**MULTI UNIT HOUSING DEVELOPMENT
LOT 19 DP 611010 & LOT 1 DP 41616
111 OCEAN PARADE, COFFS HARBOUR
Proposed by Coffs Beach Partnership**

Director-General's Environmental Assessment
Report
Section 75I of the
Environmental Planning and Assessment Act 1979

February 2007

Figure 4. Height Control Figure (from Council's Park Beach DCP)

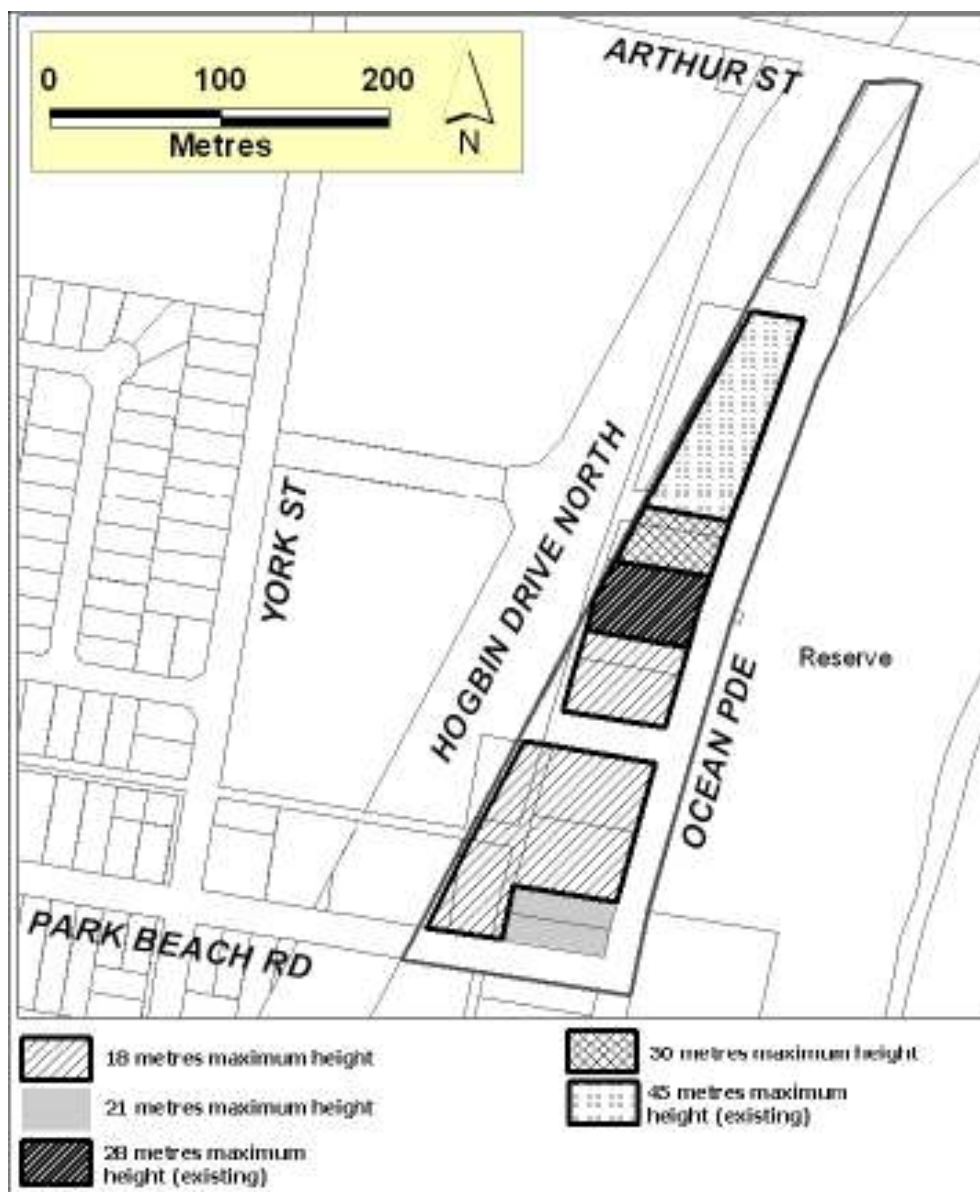
The Park Beach DCP was amended by Council on 21 June 2006 to include controls for the Park Beach North precinct. Within this precinct 6 sites are identified which are likely to be redeveloped, including the subject site. An 18m maximum height control is established for these sites except for a 30m maximum height applied to the subject site (refer to Figure 4). This 30m height limit has been established taking account of the height of existing buildings either side of the subject site, which are 45m and 28m respectively. The proposed building height of 29.8m is consistent with this existing development and the expected future character of the precinct and is therefore considered appropriate.
